### Component Identifiers:

2021-2023 vehicles that have had the Revolution® Max charging kit already installed can be identified by the parts below:

Figure 1. Engraved Rotor Part Number

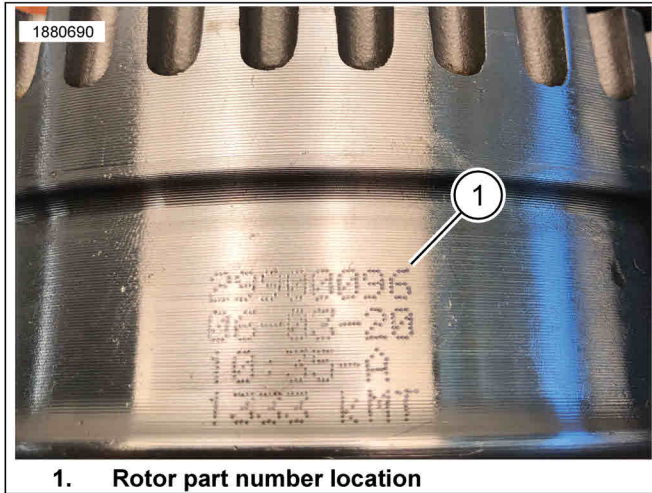
- See Figure 1. The rotor part number (1) on outer diameter of component.

Figure 2. Engraved Stator Part Number

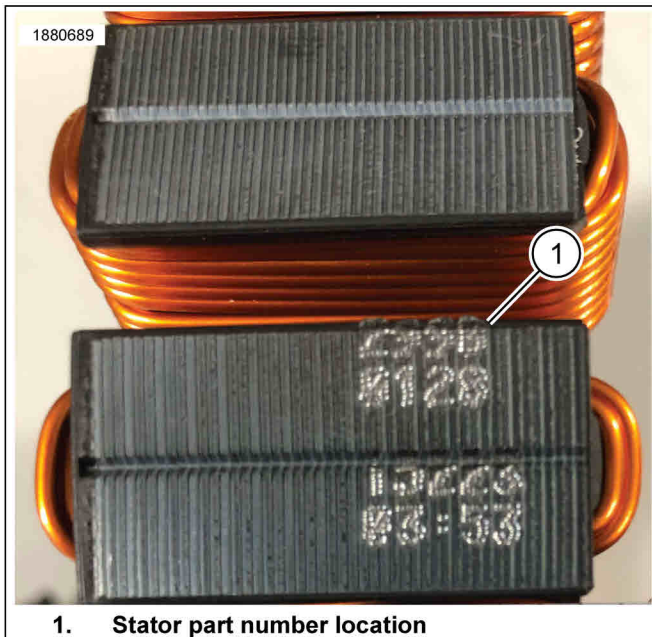
- See Figure 2. The stator part number (1) on outer diameter of component. The first line is the first portion of the part number. The second line is the remainder of the part number.

Figure 3. Coolant Manifold Designator

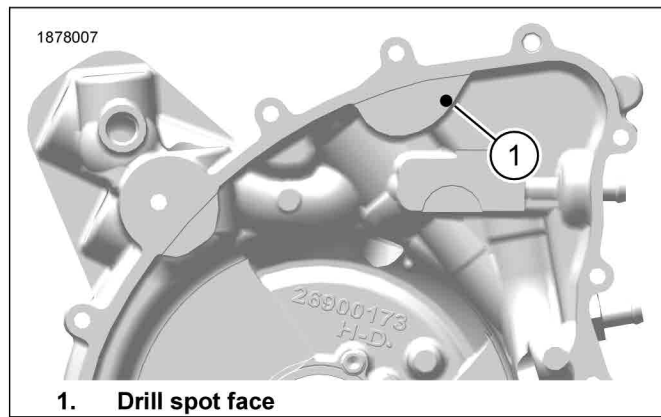
- See Figure 3. The 2024 cooling manifold has a single drill spot face (1) on the inside pad of the component.
